SERVICE BULLETIN No.1128

COACH MODEL	: T2145 and C2045
BULLETIN TYPE	: Field Change Program
MANUAL & SECTION	: Operator's Guide Book: Section 2 – Operating Instructions Spare Parts Manual: N/A
PARTS BOOK REVISION	: No
DATE	: April 29, 2005
SUBJECT	: ADA platform lift interlock – system update
TERMS & CONDITIONS	: Refer to the Warranty Information in this Bulletin.

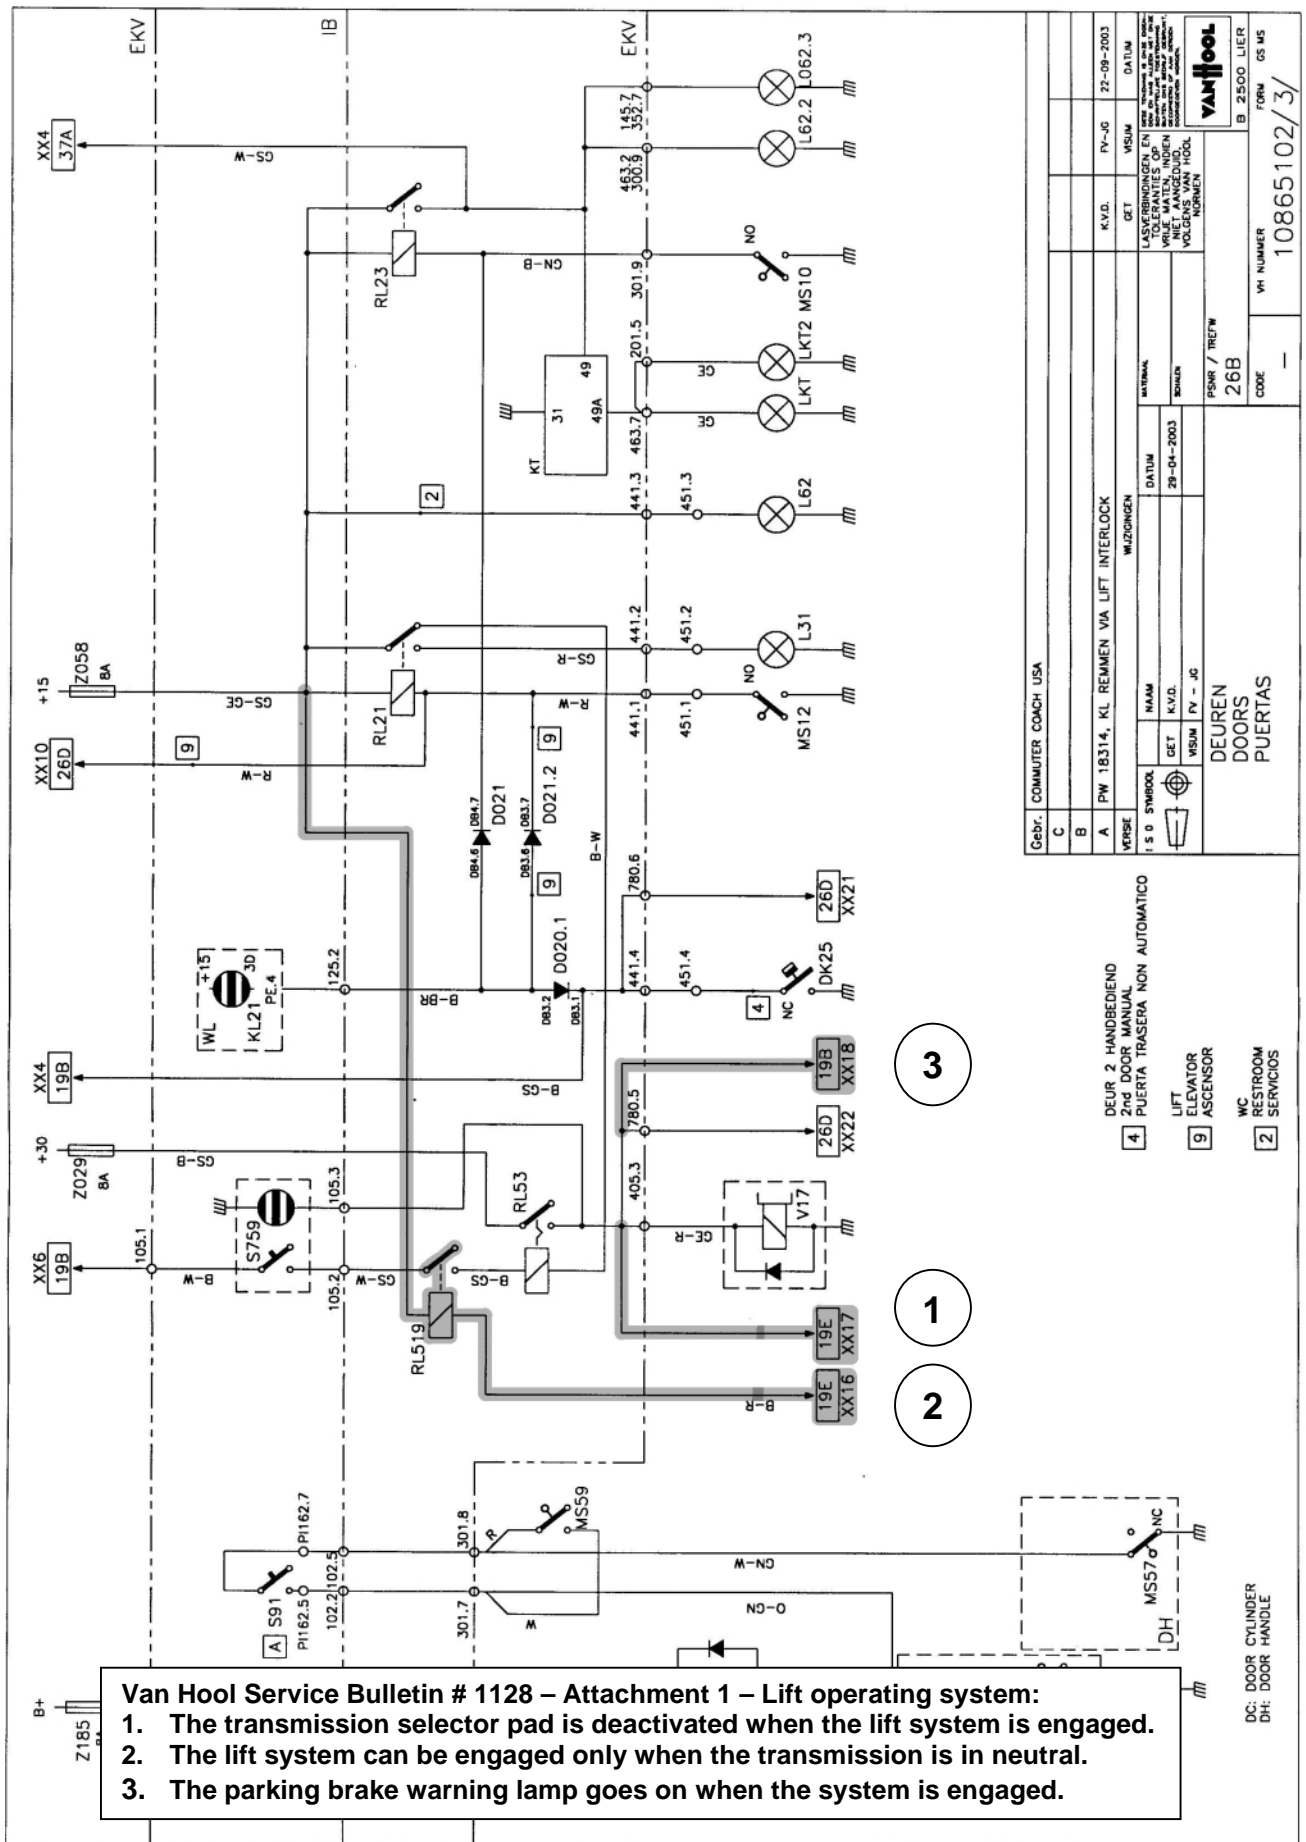
1. Attachment 1 shows how added relay RL519 must be triggered by the "Gear Selector Neutral" signal coming from the transmission, before the lift operating system can be activated. Also shown is the wire, which needs to be installed to activate relay RL53.2.

The supplemental wiring has been marked gray on the diagrams.

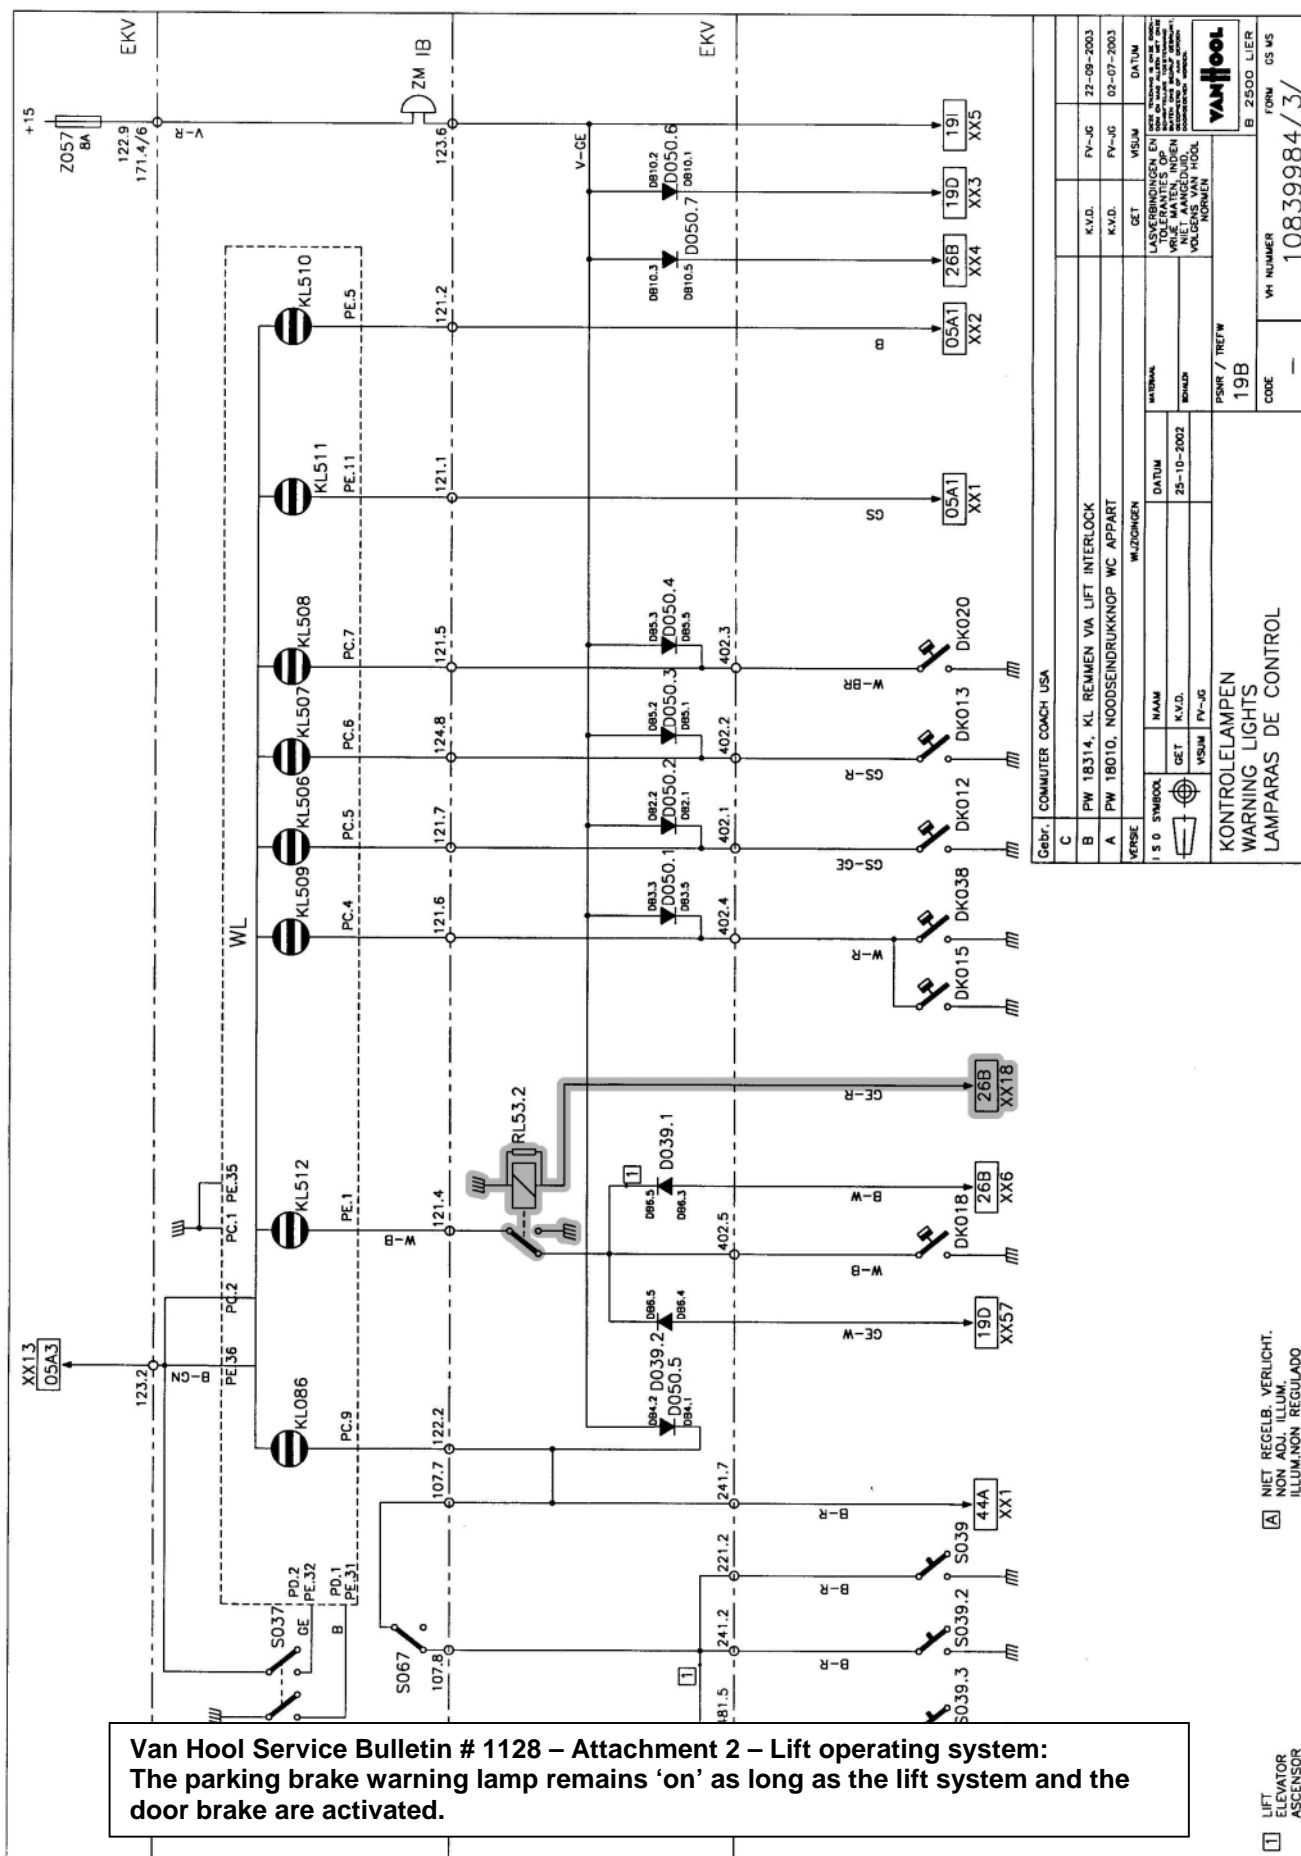
2. Attachment 2 shows how a relay RL53.2 can be installed for the parking brake warning lamp to remain 'on' as long as the lift system and the door brake are activated.
